**Model:** iR2200/2800/3300

**Ref. No. :** FF-T01-L5-000019-01

**Subject:** Preventing Wrong Detection of Cassette Size

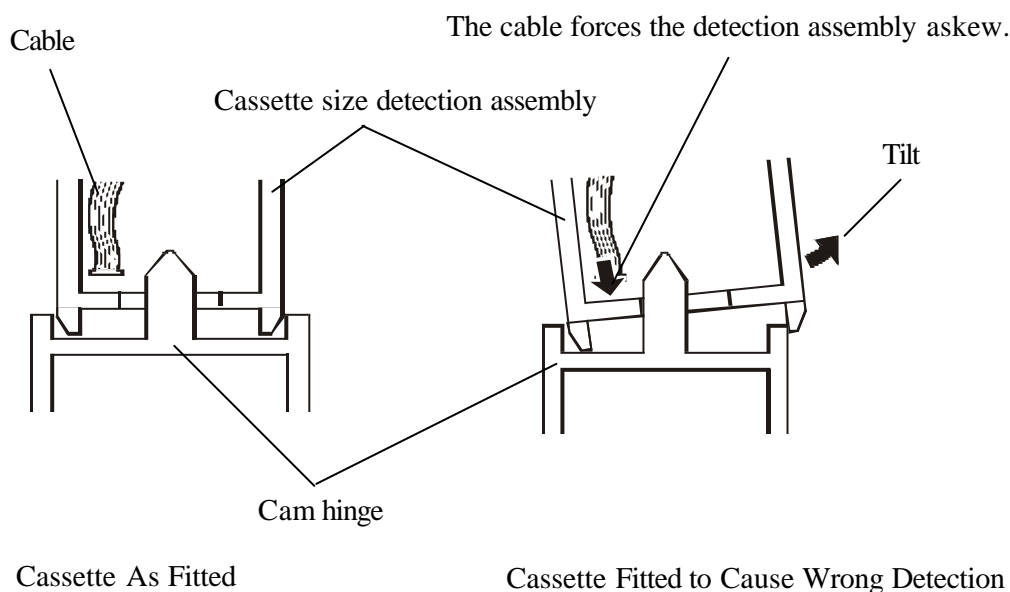
When the cassette is slid into the machine, the cable from the cassette size detection assembly can push and tilt the assembly; and the poor engagement between the assembly and the cam hinge in turn can cause wrong detection of cassette size.

The protrusion is lengthened so that the cam hinge will more easily slide into the cassette size detection assembly. At the same time, the presence of a taper ensures that the cam hinge will securely engage with the cassette size detection assembly.

## 2. Right Panel (front) (instead of FB5-4741-000, use FB5-4741-030)

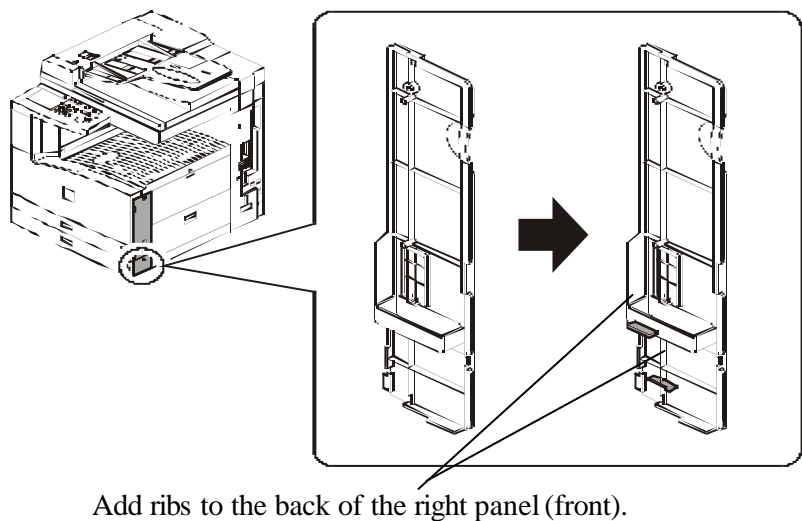
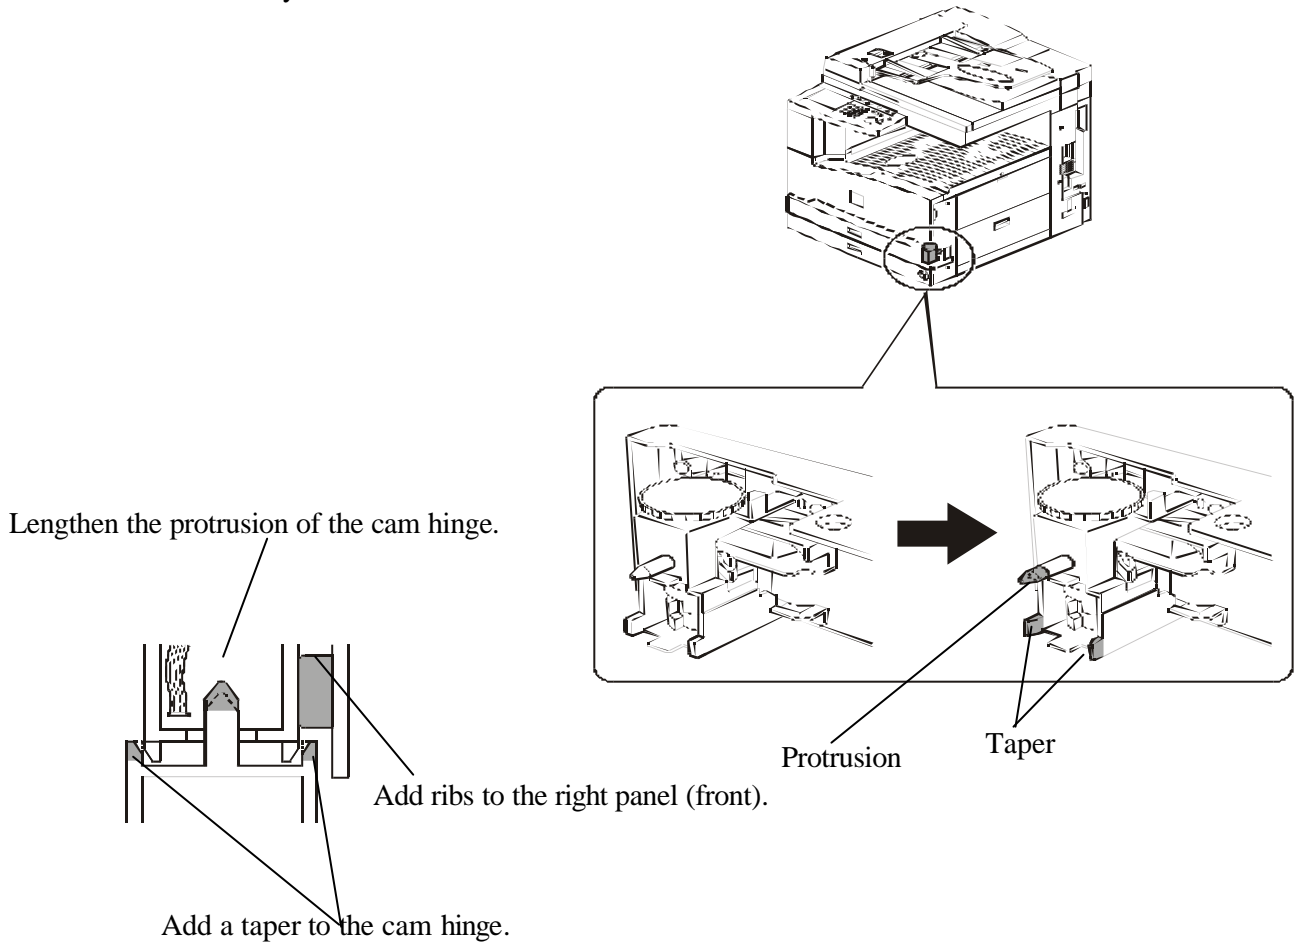
Ribs are added to the right panel (front), thus preventing a tilt of the cassette size detection assembly.

If the cassette size detection assembly fails to detect the correct size of the cassette, replace the cam hinge and the right panel (front) at the same time.
